LIVING WITH HISTORY

Certificate of Appropriateness

2911 W. STATE ST. Concordia

PTS ID 115038 COA: front porch structure and masonry

3 PROPOSED 2ND FLOOR PORCH PLAN
 SCALE: 1/4" = 1'-0"

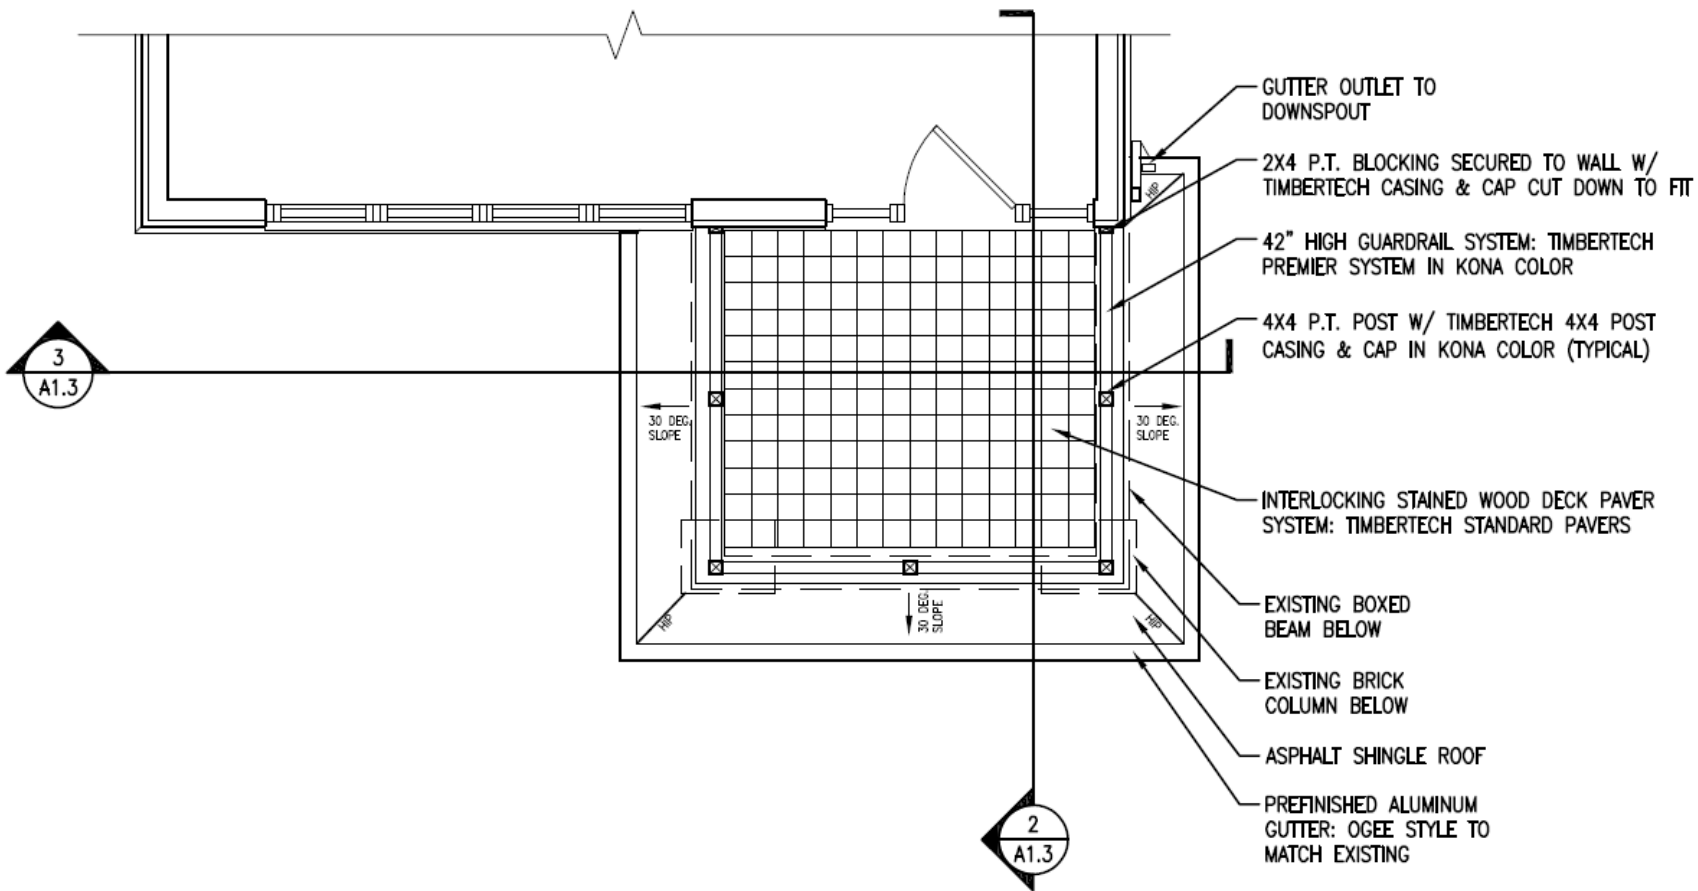
DISREGARD NEW DECKING AND NEW RAILING; THOSE FEATURES ARE NOT APPROVED AT THIS TIME.
